DEPARTMENT OF PLANNING AND PERMITTING
CITY AND COUNTY OF HONOLULU

Subject: Chapter 343, Hawaii Revised Statutes
Environmental Assessment (EA) Determination
Finding of No Significant Impact

Landowner/Applicant: Bernadine M. Barry
Agent: Sea Engineering, Inc.
Location: 91-447 Pupū Street – Ewa Beach
Tax Map Key: 9-1-30: 8
Request: Shoreline Setback Variance
Proposal: To allow (retain) a CRM wall and concrete splash deck
apron within the shoreline setback area.
Determination: A Finding of No Significant Impact is Issued

Final Environmental Assessment and Coastal Engineering Evaluation
for a Shoreline Setback Variance at 91-447 Pupu Street, Ewa Beach,
Hawaii 96706

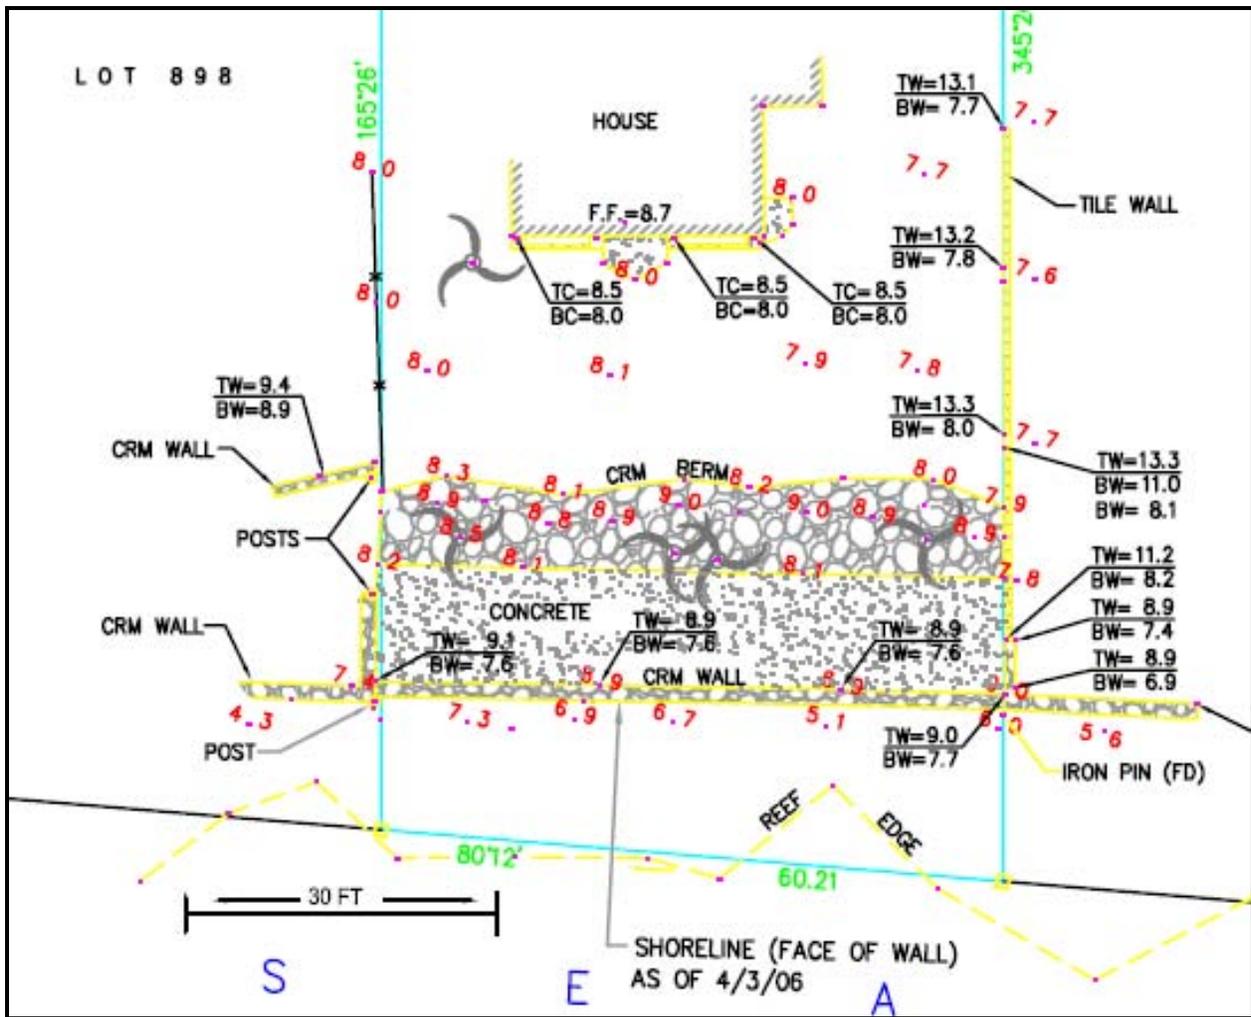
According to the shoreline survey (Figure 2-5), the subject parcel has lost 884 square feet of land to erosion, decreasing in size from 8,610 square feet to 7,726 square feet. Although the rocky

coralline limestone on which the CRM wall is constructed continues to remain stable and intact during low tide, the DEA indicates that wave runup at high tide has caused inundation of the backyard of the parcel to such an extent that it deprived the owner of reasonable use of that portion of the parcel. Figure 3-2 in the DEA further illustrates that even with the construction of the CRM wall, waves overtop it and flood the concrete deck splash apron during high tide conditions. Despite anecdotal references in the DEA to naupaka growing on approximately the same alignment as the CRM wall in the past, there is no reliable information provided at this time on the location of the shoreline prior to the construction of these improvements. If anything, the information in the DEA indicates that the shoreline would extend well inland were it not for the improvements, potentially placing both structures partially or wholly within the State Land Use Conservation District.

- A conservative value for the elevation of the seaward base of the wall, using an average of all topographic points shown in the DEA, is 6.4 feet msl. Numerical runup studies conducted by Sea Engineering for design of the new Ocean Pointe Marina, a nearby area with similar wave exposure, nearshore bathymetry, and shoreline morphology, show that the upper reaches of the wash of the waves (i.e. wave runup) in a non-storm situation can be expected to reach that elevation at a statistical frequency of once per year. Wave overwash of this elevation will therefore occur on a less frequent basis during statistically more extreme wave events, including storms and hurricanes.

The term "erosion" that is used on the survey drawing, therefore, does not refer to physical loss of material from the shoreline, but is used to designate the difference between the "highwater mark" and the "shoreline". In other words, "erosion" defines the area of private property that lies between the old boundary line and the proposed new boundary line separating the Urban District from the Conservation District.
